Cover Letter for KLF Proposal PR12-17-001 Submission to PAC45

Response TAC Physics Report

Response on ITAC Report

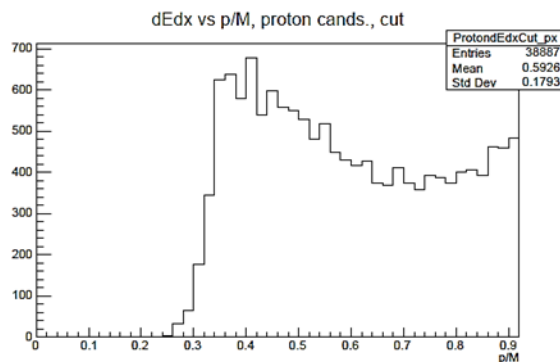
Q2: Simulations show that the minimum recoil proton momentum detectable with the proposed target and current GlueX detector is about 0.5 GeV/c as shown in Figure 45. This includes the full K_L momentum spectrum as shown in Figure 16. It is not obvious that at low initial K_L momenta the proposed measurements can be exclusive and detect the recoiling proton which is essential for vertex

reconstruction. Note that most events in Figure 37 (low t) would be undetectable in an exclusive measurement.

A2: Figure 45 of the proposal shows particle identification plots for protons in two regions of the GlueX detector. For protons with $\theta < 10^\circ$ (upper right of Fig. 45), the threshold is in indeed $p = 0.5$ GeV/c. However, for recoil protons produced at large polar angles the threshold for detection is $p = 0.3$ GeV/c as shown in the upper left panel of Fig. 45 and figure below of reconstructed proton p/M for the $K_L p \rightarrow K_S p$ reaction.

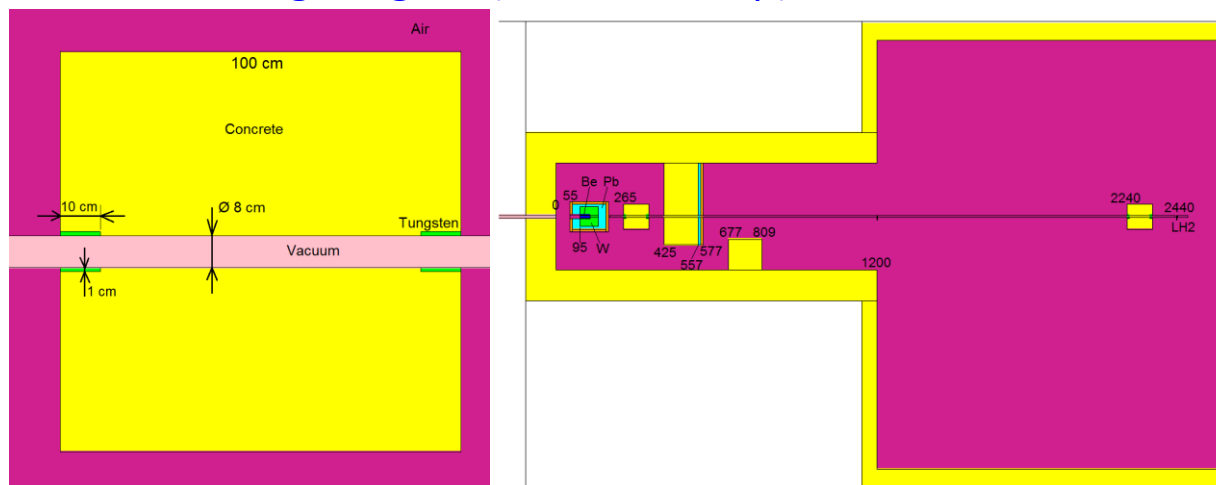
Q3. There is no information about the two collimators that are shown as part of the K_L beam line right after the sweeper magnet and upstream of the GlueX detector (Figs. **14 & 20**). This second collimator is directly competing with the LH target for space on the upstream platform. No information about the collimator material, its dimensions, bore diameter and weight are available. This is important to determine the floor load, in particular on the upstream detector platform.

A3: Collimator C1 is a part of the current Hall D photon beam line while collimator C2 is the same. The material for both collimators is concrete with small tungsten components. The sizes are given on the left figure below (view from top). The maximum height above the floor is 340 cm. The location of both collimators is shown in the right figure (view from top).
